# Request for Permit Modification

## Units Proposed for NFA

### Volume II

LA-UR-96-3357

Figure 4-9. Location of site investigations for PRS 18-001(c)

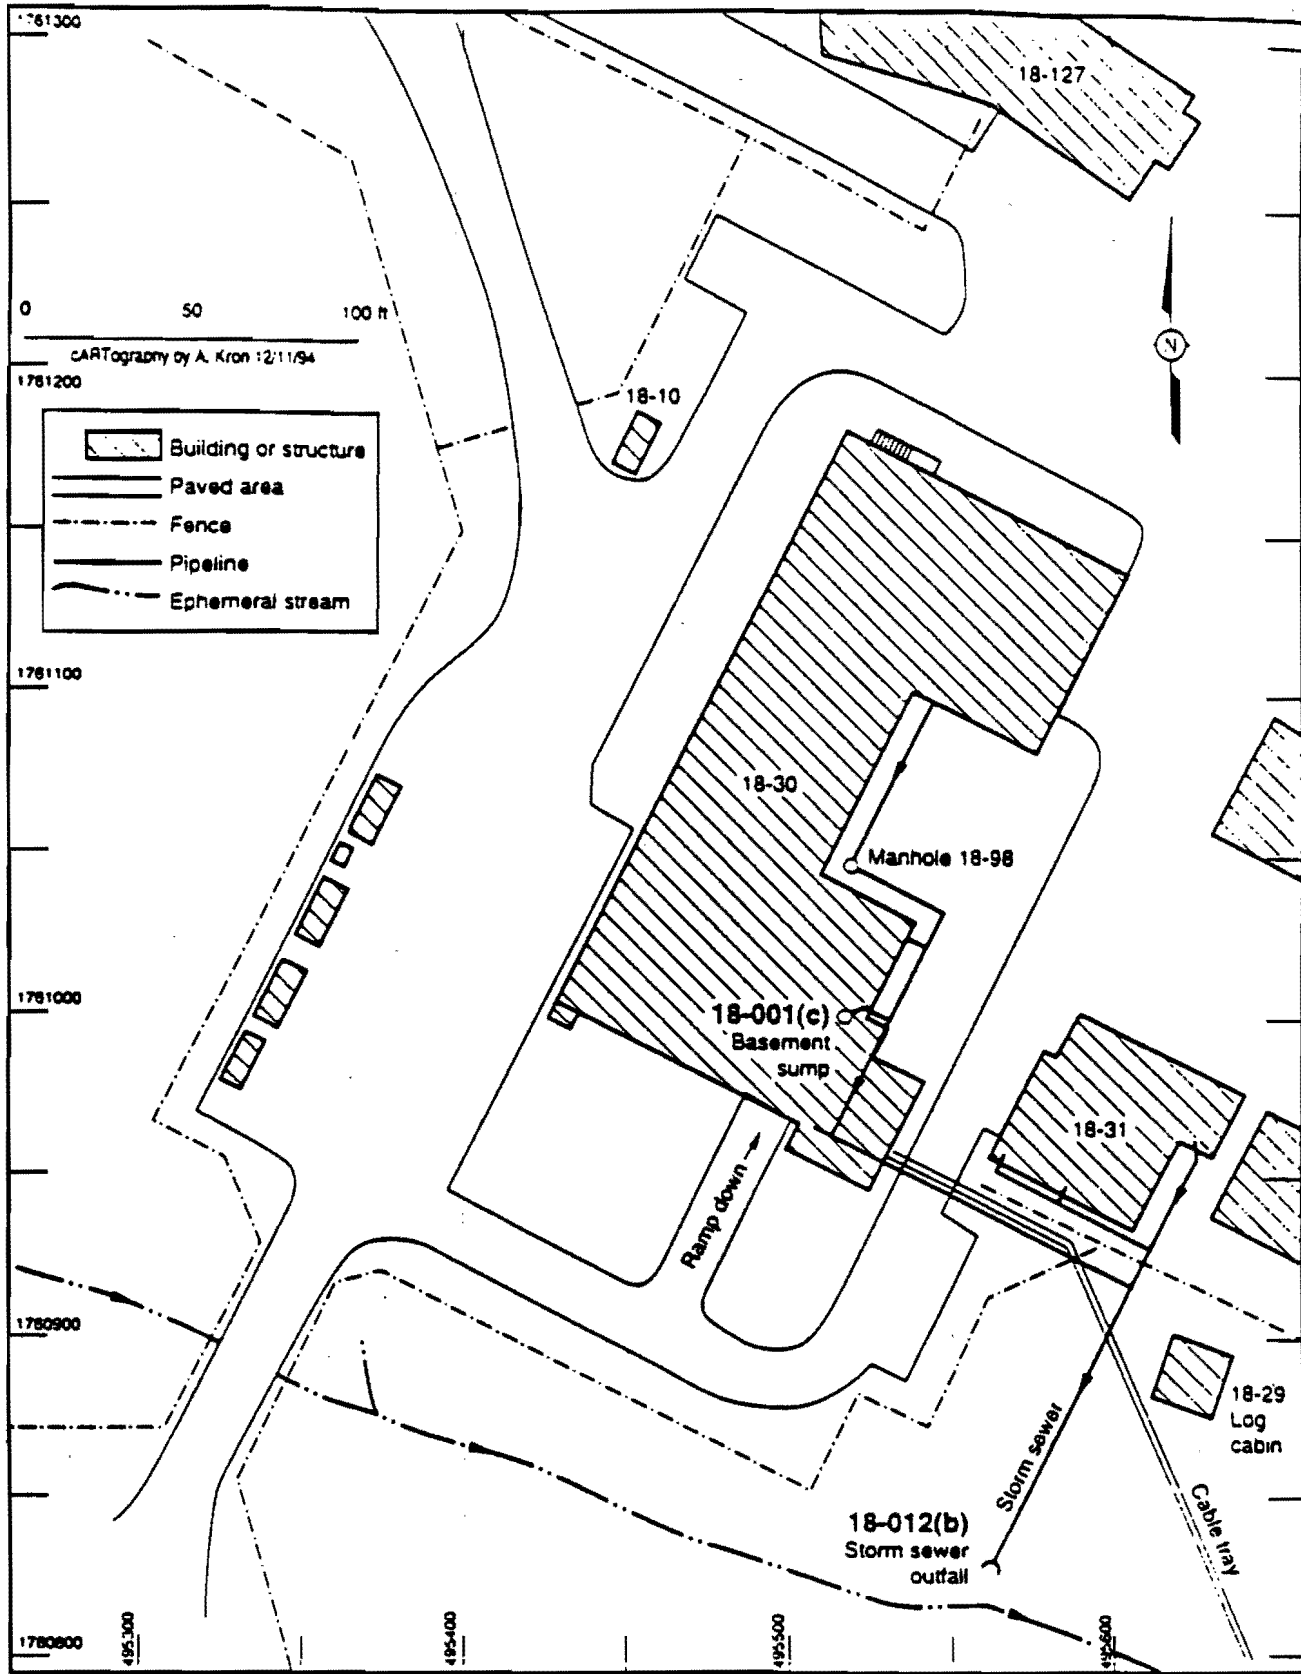
5. Figure 4-8, p. 4-12. Please include the sampling identification number for each sample point taken.

See revised Figure 4-8.

Figure 1-4. Sampling details for SWMU 36-002.

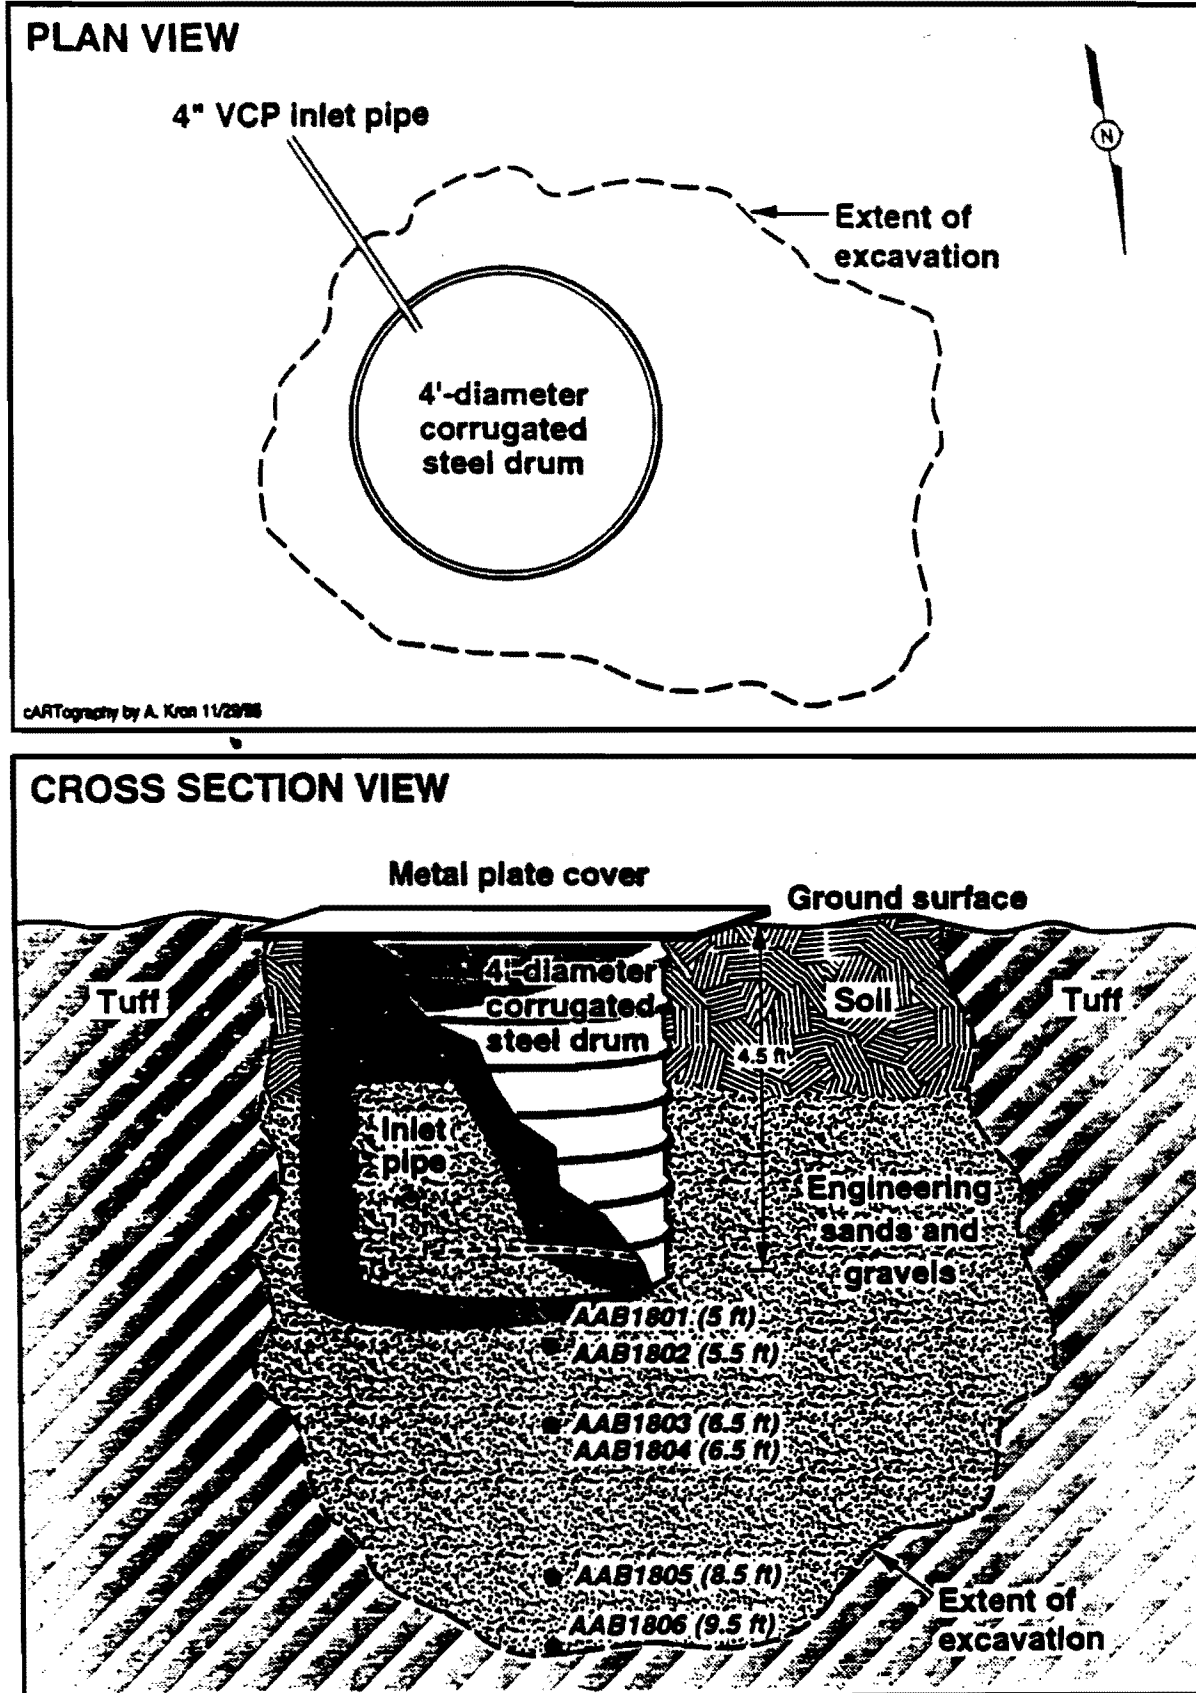
1. Figure 1-4 : The figure for the sump should fill this entire page which would allow for clearly indicating where sample locations were taken. A cross-sectionally view should also be provided indicating the depth of samples.

1. Figure 1-4 has been revised to show more detail from the top and side view. See revised Figure 1-4.
2. This RFI mistakenly reported that the US Army Toxic and Hazardous Material Agency (USATHAMA) method was used for analyzing the high explosives samples. In fact, data package results indicate that EPA SW-846 Method 8330 was used for the analyses. Field Unit 2 personnel are aware that the USATHAMA is not approved by EPA and will specify the use of EPA SW-846 Method 8330 in the future for analyzing the high explosives samples. 
3. LANL's Environmental Restoration Project will programmatically address the EPA's concerns and issues regarding the conduct of human health and environment risk assessments based on the EPA risk assessment meeting held at LANL in September of this year.
